REVIEW OF:

TECHNICAL POSITION ON REPOSITORY DESIGN-THERMAL LOADS,  
NRC PUBLIC COMMENT DRAFT: AUGUST, 1990

Center For Nuclear Waste Regulatory Analyses  
San Antonio, Texas

December 5, 1990

Figure 1. Suggested Methodology to Demonstrate Compliance with 10 CFR 60.133(i)

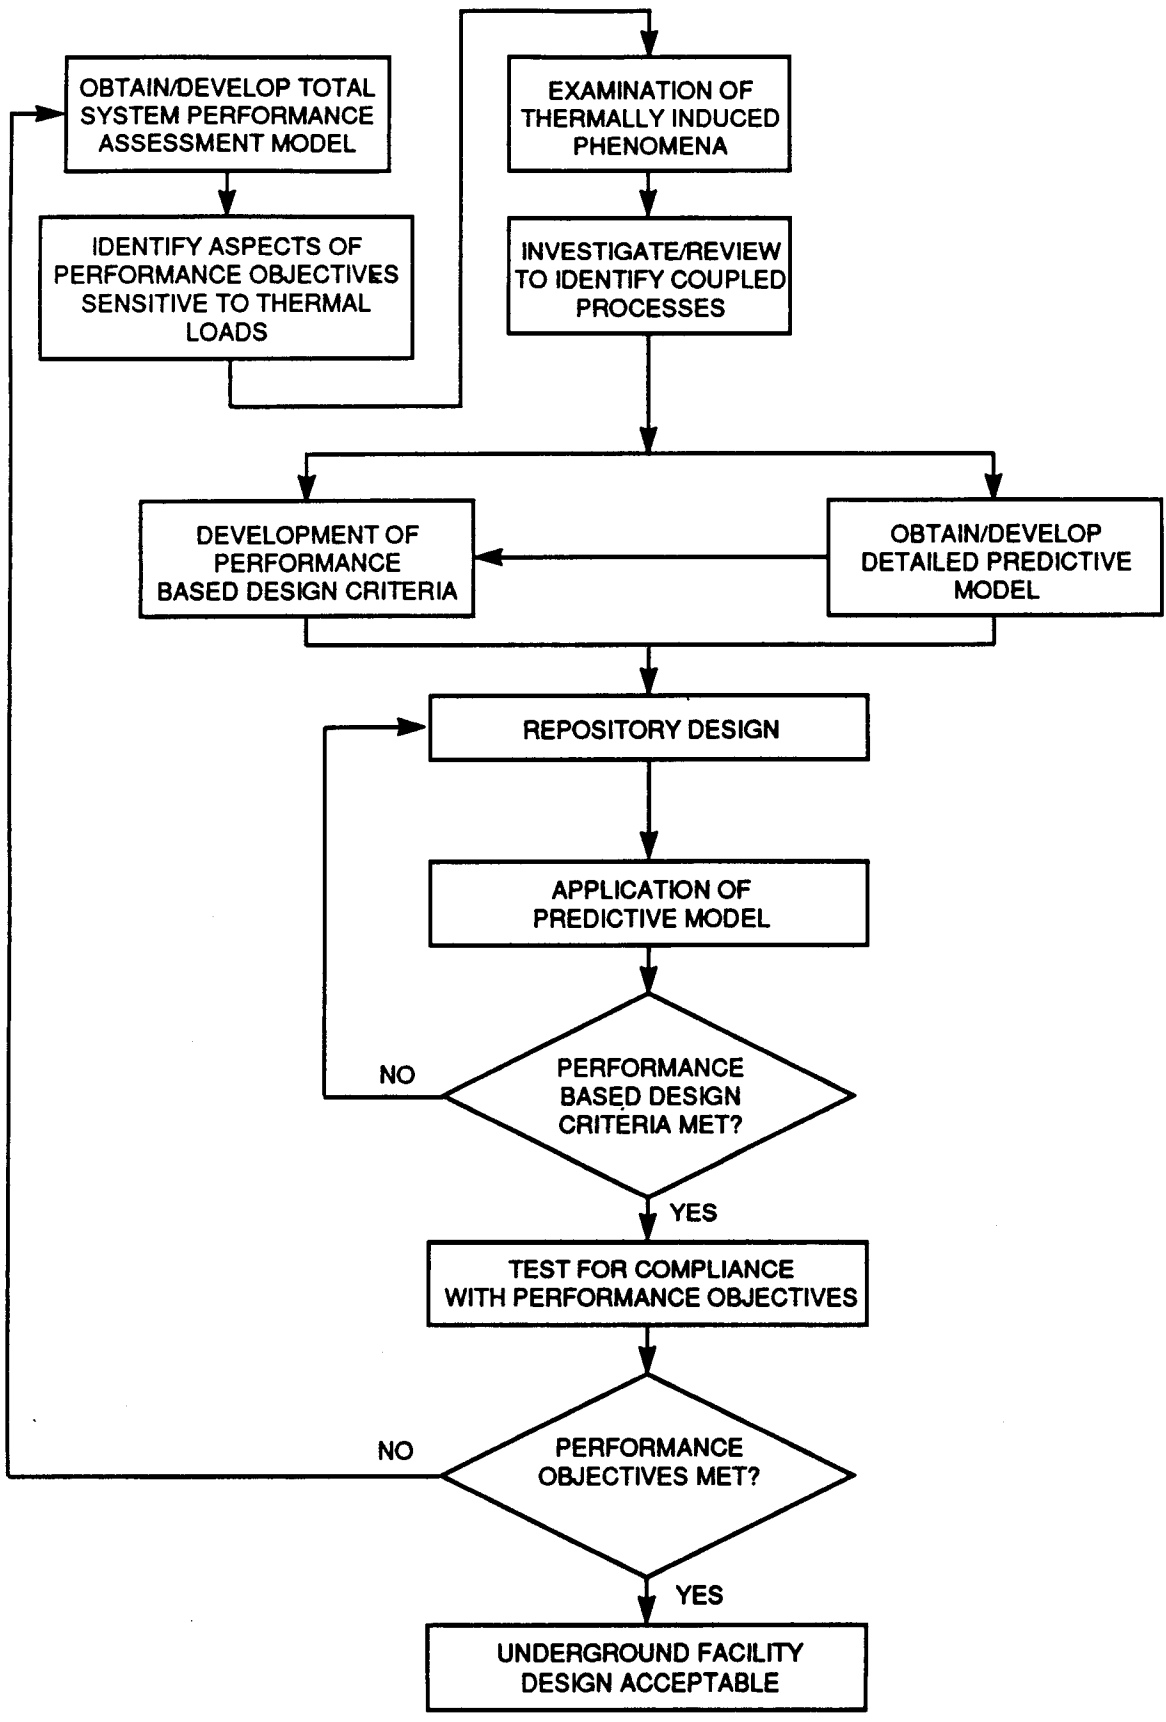
Section 3.1 and Figure 1

This technical position commences with detailed lower-level calculations and involves top-level performance assessment only very late in the process (Step 7 in Figure 1). In the context of the top-down approach to "total system performance assessment" (particularly the concept of iterative performance assessment) that is currently envisioned by the NRC and CNWRA staffs, this approach is inconsistent.

The thermal analysis will be a detailed analysis for thermally induced complex phenomena for demonstrating compliance with 10 CFR 60.133(i) which may be treated in the "total system performance assessment" model in a simplified or generalized manner. Thus indirectly it will be a sub-set of "total system performance assessment" model and it is essential that top-down approach be used in this technical position.

- 3.1 The following methodology, see Figure 1, can be used to demonstrate compliance with 10 CFR 60.133(i):
  - 3.1.1 Determine aspects of the performance objectives that are sensitive to "thermal and thermomechanical response of the host rock and surrounding strata, and groundwater system" using currently available model for "total system performance assessment."

- 3.1.2 Examine the thermally induced phenomena in the host rock and surrounding strata, and ground water system.
  - 3.1.3 Perform study or review to identify coupled processes.

- 3.1.4 Develop performance based design criteria for the underground facility.
  - 3.1.5 Obtain or develop detailed predictive model for analysis.
  - 3.1.6 Design repository and perform analysis with predictive model and compare results to performance based design criteria.

- 3.1.7 Use the predicted results in a "total system performance assessment" model to evaluate compliance with the aspects of performance objectives that are sensitive to thermal loads.

- 3.1.8 Modify both the "total system performance assessment" model and "detailed predictive" model based on findings above and iterate.

Sections 3.0, 3.1, 4.0, and 4.3, and Figure 1 need to be revised to incorporate the suggested resolution. In addition to these, sections 4.1.1 to 4.1.5 need to be expanded and renumbered to make consistent with suggested sections 3.1.1 to 3.1.8.
